SUPPLEMENTAL SPECIFICATIONS

1988 English Standard Specifications for Highways and
Bridges

1995 Metric Standard Specifications for Highways and
Bridges

JUNE 15, 2012

FIGURE 1

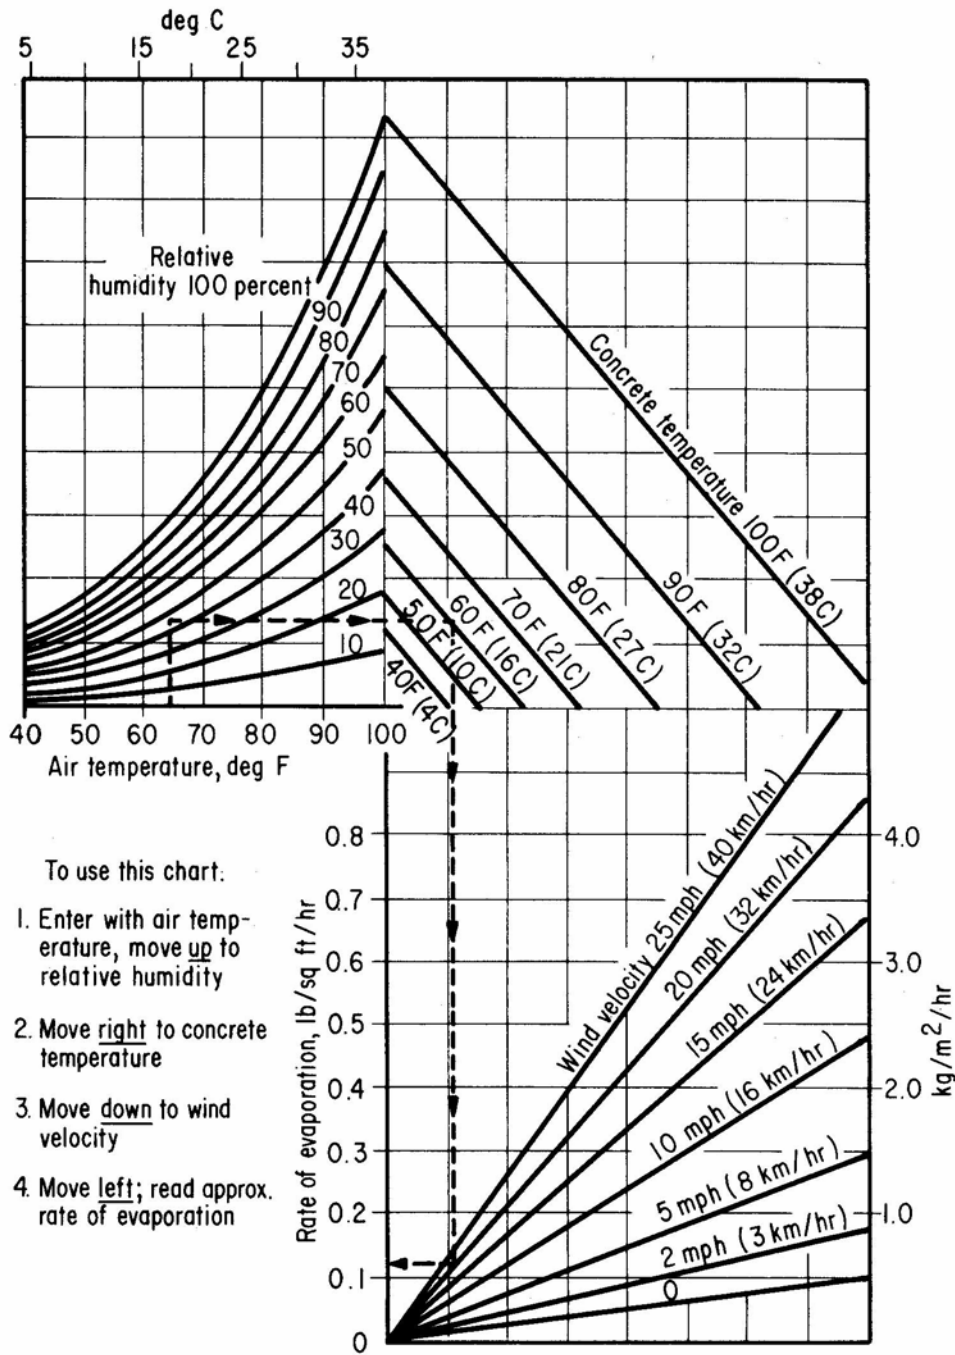
The weight of the finishing machine(s) shall not cause unaccounted deflection of the bridge members or falsework. The machine shall travel on steel rails, pipe or other approved grade control, which shall be supported by vertical supports securely fastened in place at a maximum spacing of 2 feet (200 mm) to prevent any appreciable deflection between rail supports. Screed rail supports may be located inside or outside of the placement width. Prior to placing the concrete, screed rails shall be completely in place, and accurately set to insure finishing of the concrete deck surface to the elevations shown on the Plans. The supports for the rails, if embedded in the deck concrete, shall be of the type that can be removed without disturbing the concrete.

Screed rails shall be set entirely above the finished surface of the concrete and shall be supported in a manner approved by the Engineer. Where stud type shear connectors are available, welding to the studs will be permitted. Where no studs are available, other means of attaching the screed rail supports shall be provided. No welding will be permitted directly on stringer or girder flanges or cover plates in tension areas, nor in areas subject to stress reversal, for attaching either screed rail supports of any type. Any welding in compression areas shall be approved by the Engineer.

Screed rail supports set in the concrete shall be so designed that they may be removed to at least 2 inches (50 mm) below the surface of the concrete. Voids created by removal of the upper part of the screed rail supports shall be filled with mortar having the same proportions of sand and cement as that of the slab or wearing surface. The mortar shall contain an approved additive in sufficient proportions to produce non-shrink or slightly expansive characteristics. Screed rail supports shall not be treated with parting compound to facilitate their removal. Rails for finishing machines shall extend beyond both ends of the scheduled length for concrete placement. The extended length shall be of sufficient distance to allow finishing machine(s) to clear the concrete to be placed.
